BRIEFING NOTE

To:	All Councillors
From:	Simone Plummer, Director Planning
Date:	4 August 2026
Subject:	Development Assessment Update - State Significant Developments & Planning Reform Matters

40-76 William Street, Leichhardt (SSD-119545240)

Inner West Council Response: SSD-76927247-Mod-1 – The Timberyards by RTL Co.

Figure 1: Extract of the tight turn within the basement

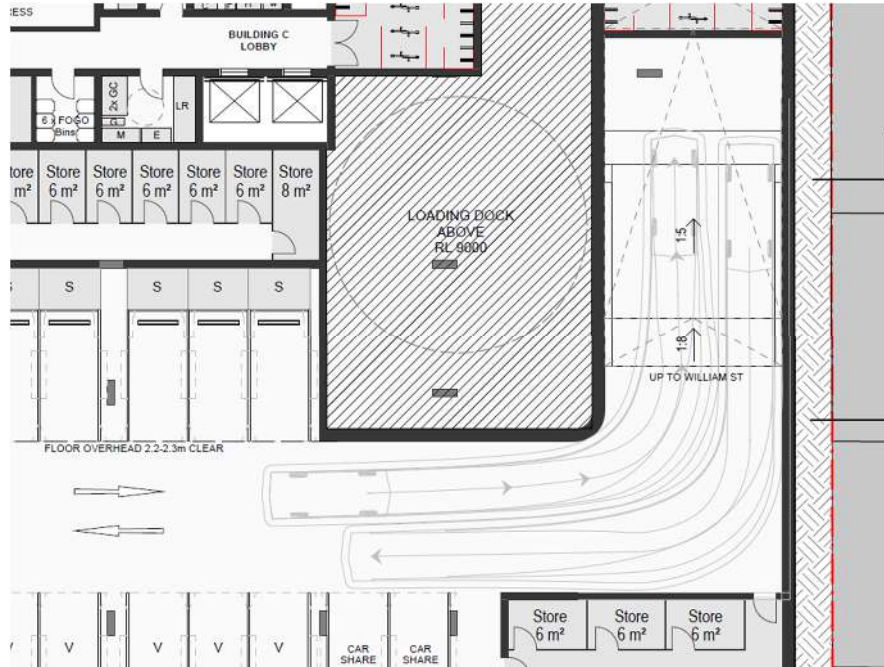
- The turn analysis for residents entering and exiting the basement appears constrained at the corner of the basement car park ramp. Swept path analysis in accordance with the relevant Australian Standard should be provided to demonstrate that standard vehicles can pass and to confirm the functionality of the car parking area. (See figure 1 below)

Figure 2: Survey extract from DA/2021/0437 depicting the encroachments and windows on the boundary (outlined in red)

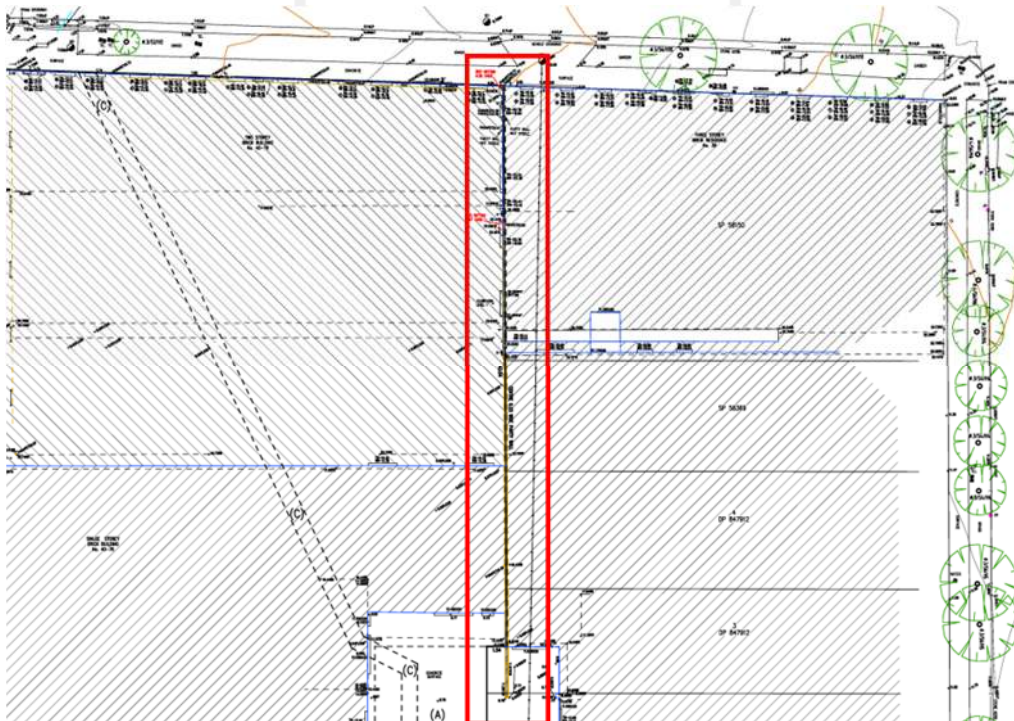
Survey information does not appear to have been included in the application package and, as such, an accurate representation of the surrounding context has not been depicted. Notwithstanding this, Council has reviewed a copy of the survey provided under DA/2021/0437 and notes that there are a number of windows and encroachments at the eastern boundary of the site, shared with the respective western boundaries of 38 William Street and 84-80 Francis Street.
